SP2025-014: Site Plan for 2351 Harbor Heights Drive

PROJECT NUMBER: SP2025-014
PROJECT NAME: Site Plan for a Retail/Office Building
SITE ADDRESS/LOCATIONS: 2351 HARBOR HEIGHTS DR

CASE CAPTION: Discuss and consider a request by Jimmy Strohmeyer of Strohmeyer Architects, Inc. on behalf Dan Bobst of HH Retail Center, LP for the approval of a Site Plan for a Retail/Office Building on a 2.893-acre parcel of land identified as Lot 2, Block B, Harbor District Addition, City of Rockwall, Rockwall County, Texas, zoned Planned Development District 32 (PD-32), situated within the IH-30 Overlay (IH-30 OV) District, addressed as 2351 Harbor Heights Drive, and take any action necessary.

DEPARTMENT	REVIEWER	DATE OF REVIEW	STATUS OF PROJECT
PLANNING	Bethany Ross	04/24/2025	Needs Review

1 NORTH ELEVATION
3/16" = 1'-0"

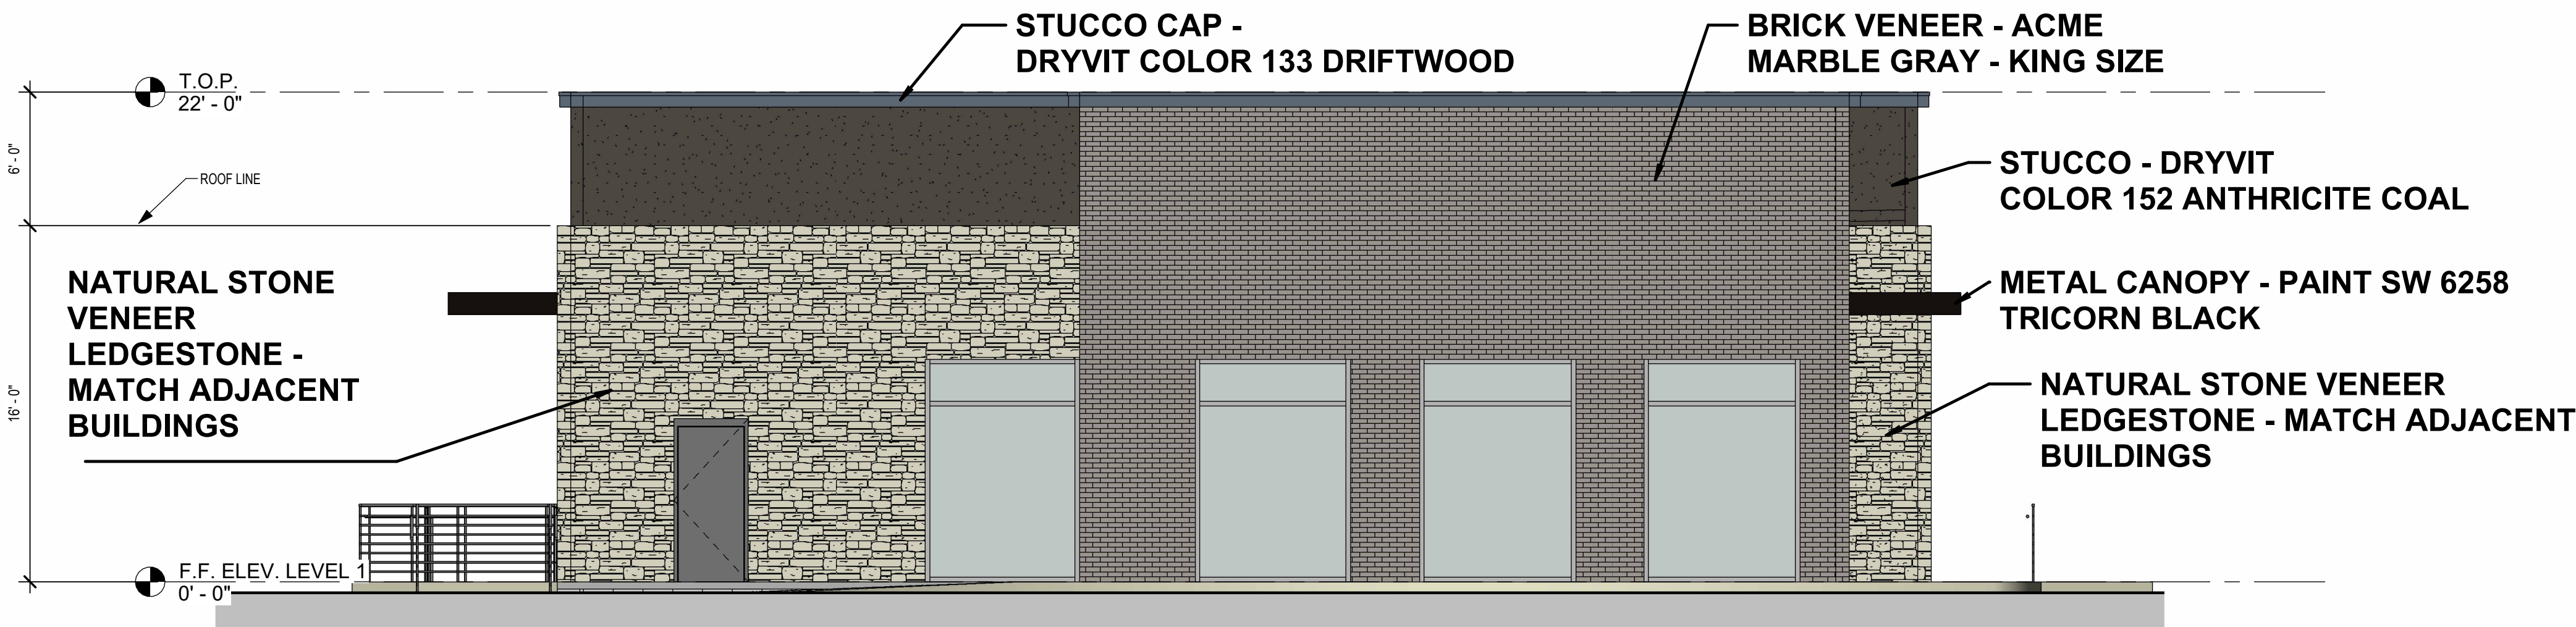
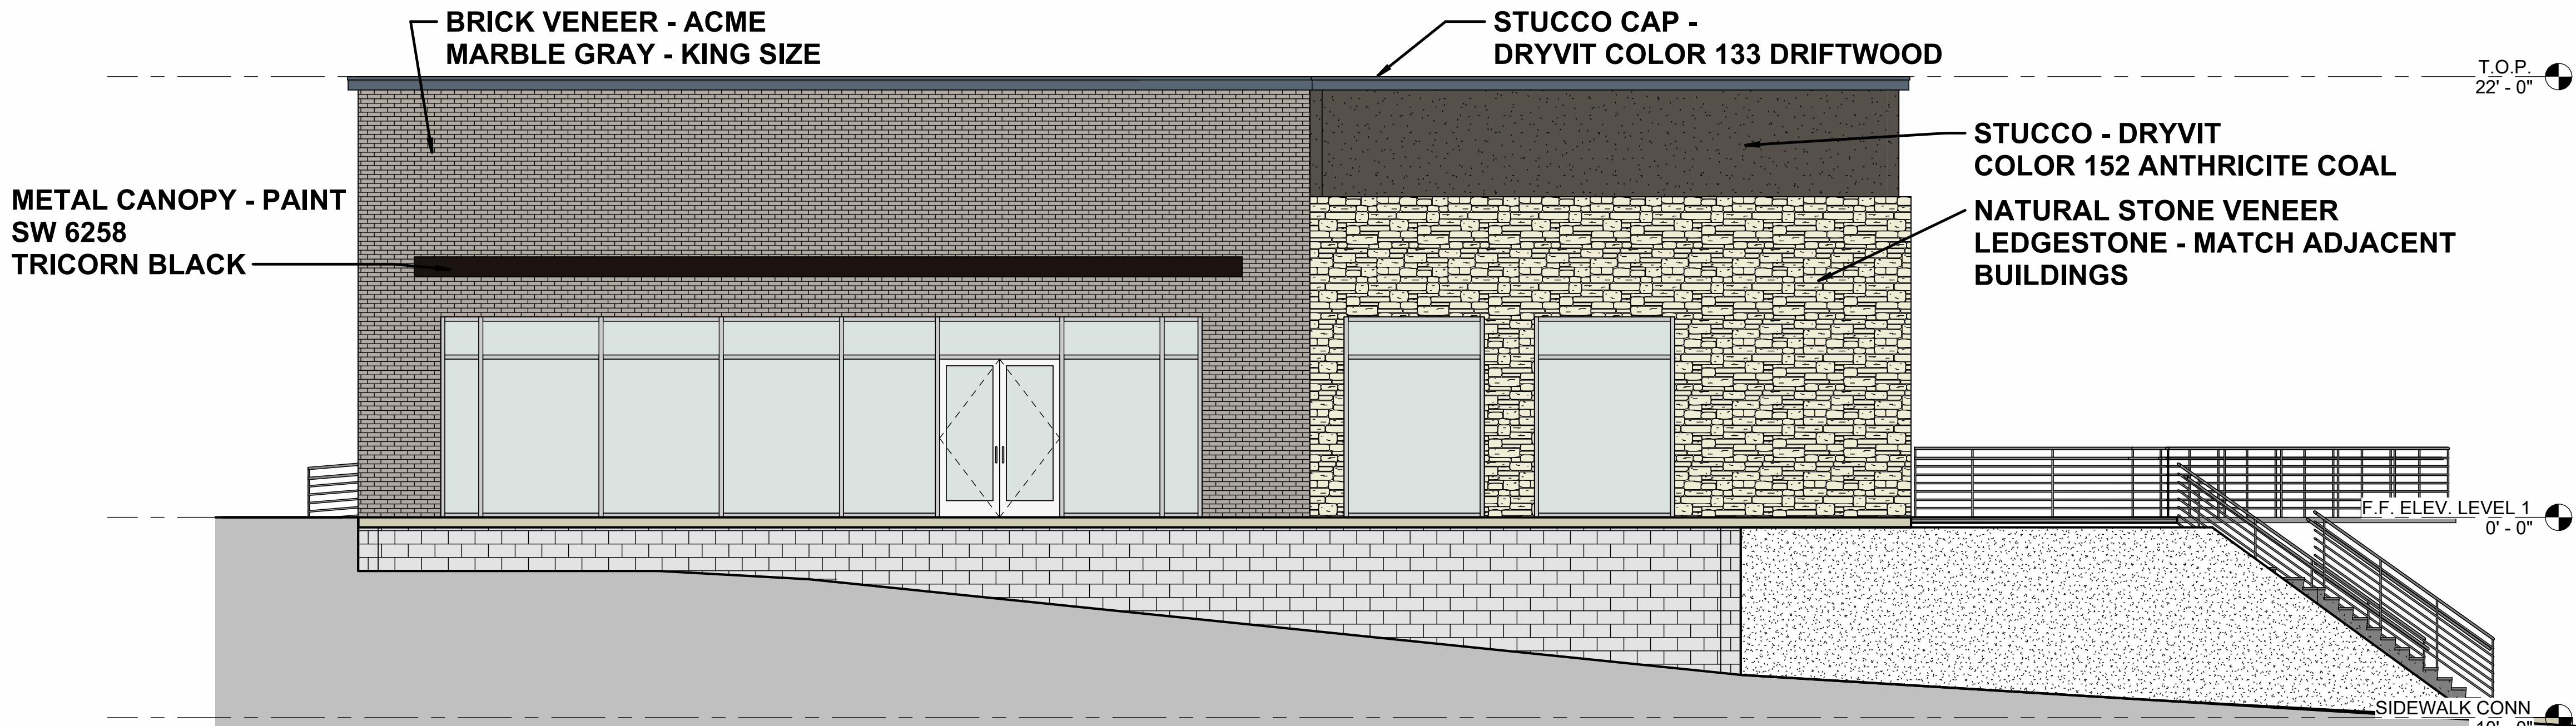
- (4) The proposed buildings' facades do not meet the Commercial Building Articulation Standards for wall projections. (Subsection 04.01.C, of Article 05, of the UDC) This will require a variance from the Planning and Zoning Commission.

- (5) All structures that have a building footprint of less than 6,000 SF shall be constructed with a pitched roof. (Subsection 06.02.C.2, of Article 05, of the UDC) This will require a variance from the Planning and Zoning Commission.

- (6) All buildings shall be architecturally finished on all four (4) sides utilizing the same materials, detailing, articulation and features. (Subsection 06.02.5, of Article 05, of the UDC and Planned Development District 32 [Ordinance 19-25]). This will require a variance from the Planning and Zoning Commission.

- (1) Four-sided Architecture. According to Article 05, General Overlay District Development Standards, of the Unified Development Code (UDC), “all buildings shall be architecturally finished on all four (4) sides utilizing the same materials, detailing, articulation and features. In addition, a minimum of one (1) row of trees (i.e. four [4] or more accent or canopy trees) shall be planted along perimeter of the subject property to the rear of the building.” In this case, the proposed building does not meet the articulation standards for all four (4) facades.

LANDSCAPE PLAN

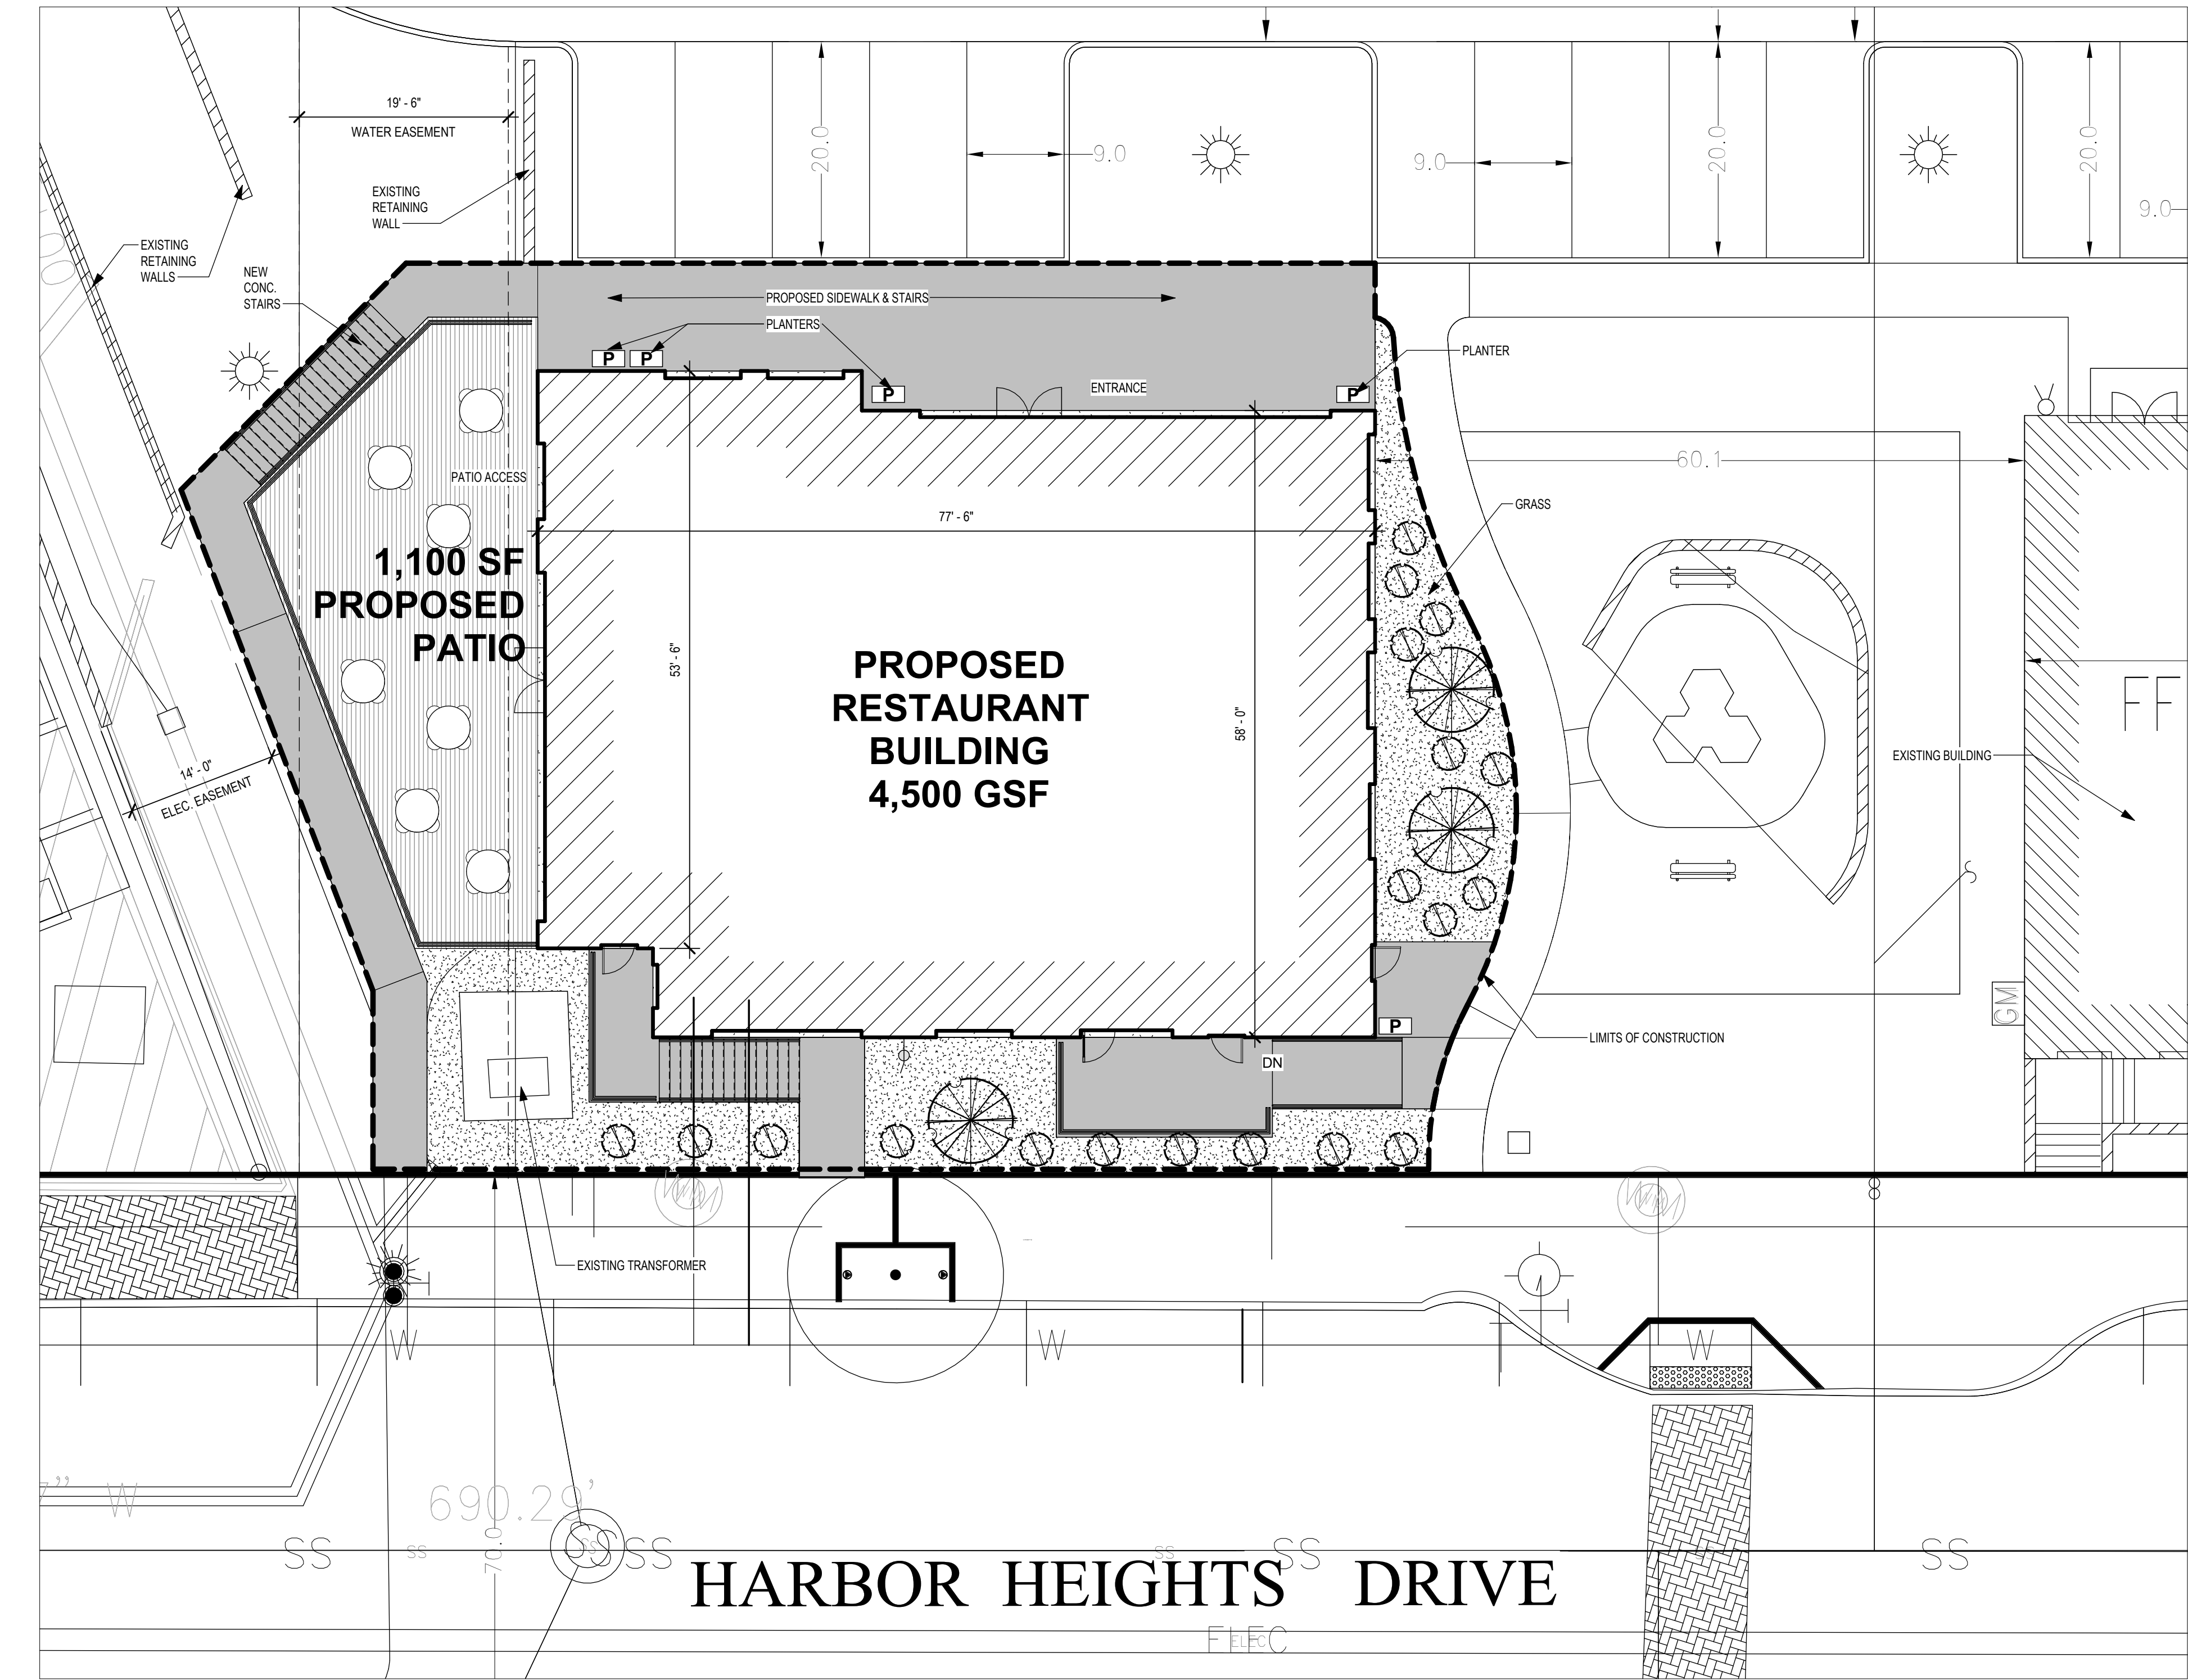
- 1) Provide evergreen shrubs screening the existing transformer. (Subsection 01.05.C, Article 05, of the UDC)
